December 21, 2011

Little Cedar Creek Floodplain Mapping between Frontier Lane and Highway 56

CEDAR CREEK AT THE MALL **FLOOD PLAIN** OLATHE, KANSAS

FIG. 1

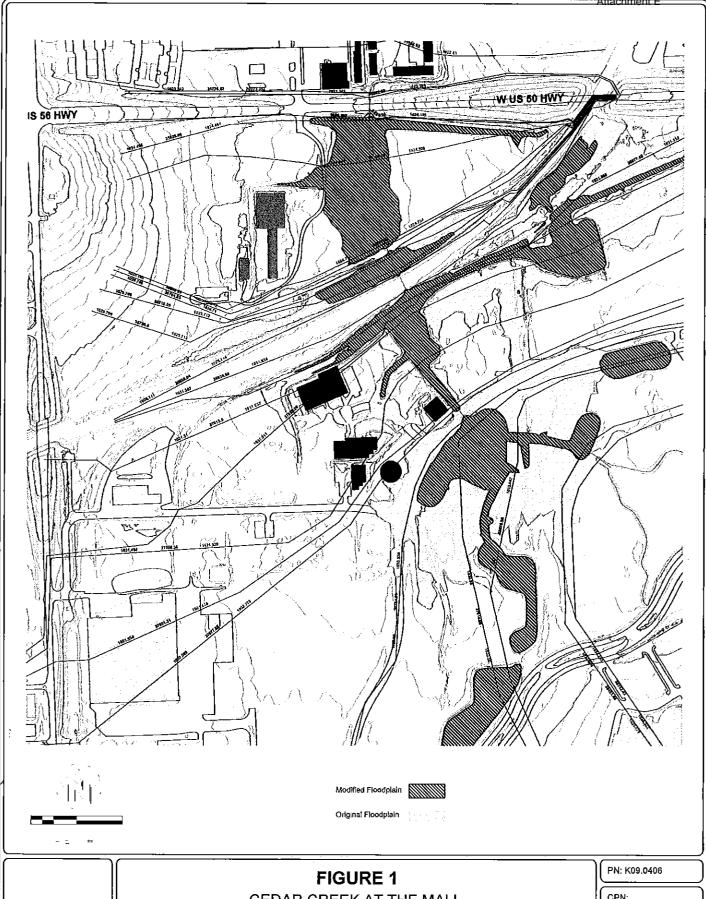
The City conducted an analysis of the floodplain, and has determined that consideration of both 1) utilization of the existing detention ponds and 2) removal of a downstream culvert reduces the floodplain by approximately 3.6 feet (See attached Report). Thus, by making these considerations the footprint of the floodplain would be primarily contained within existing drainage easements (See Figure 1).

The removal of the railroad spur and culvert downstream of the railroad tracks was evaluated as a potential measure to reduce water surface elevations upstream of the railroad culvert. Removing the culvert reduced the 100 year water surface elevation south of the railroad tracks approximately 3.6'. While the reduced water surface elevation exceeds the depths calculated in the 1988 stormwater report, the limits of inundation are similar. The attached exhibit illustrates the change in the 100 year floodplain when the above referenced modifications are made to the Cedar Creek Watershed Study HEC-RAS model.

The analyses completed for this report assumed that minimal topographic changes will be made to the site and that the railroad spur downstream of the railroad will be removed prior to development. The following design criteria must be considered when a final site development plan is reviewed for approval.

- The peak 100 year discharge throughout the site must be not exceed 340 cfs. This
 includes providing compensatory storage for fill placed within the floodplain.
- The railroad spur must be removed, or other equivalent hydraulic improvements must be provided.

- While the floodplain limits are similar, the 100 year water surface elevations will most likely exceed those presented in the 1988 stormwater report, so the basis of 100 year freeboard will be the site specific stormwater report.
- The Cedar Creek Watershed Study identified a flood risk for several buildings adjacent to Frontier Circle. If the low adjacent grade of the buildings is lower than the revised 100 year water surface elevation, a LOMA may be completed to verify that the buildings are elevated above the 100 year floodplain.
- The hydrologic impacts to the property north of the railroad must be acknowledged by the property owner or otherwise mitigated.
